ORIGINATION FORM

Proposed Revisions to a Standard Plans Index (Please provide all information — Incomplete forms will be returned)

Index Number: 700-109

Index Title: Traffic Controls for Street Terminations

OBJECT MARKER DETAIL

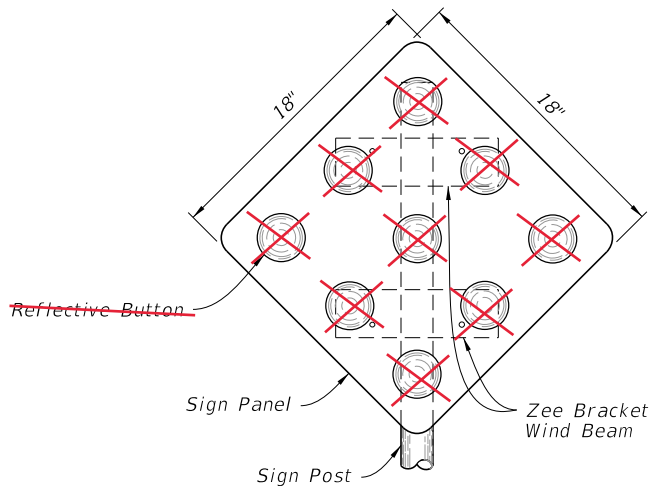
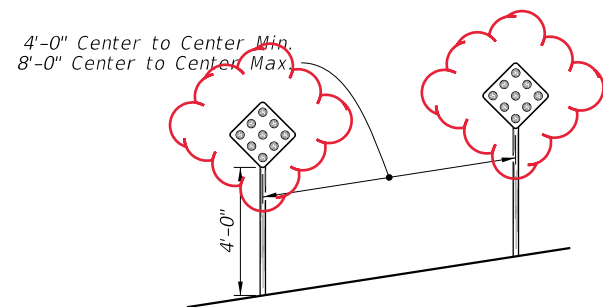
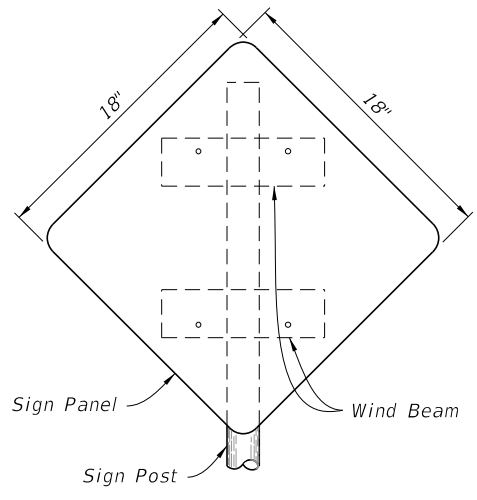
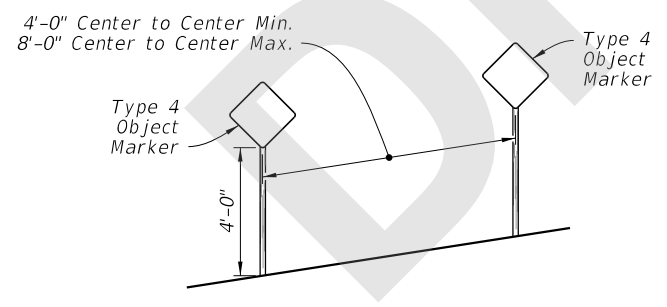
Removed Reflective Buttons from the Type 1 Object Markers.

For Type 1 Object Markers, the MUTCD allows both of the styles OM1-1 (with Reflective Buttons) and OM1-3 (without Reflective Buttons). The performance, retroreflectivity, and durability of the sheeting has improved over the years and the markers perform better without the Reflective Buttons. The Spec change is also being submitted.
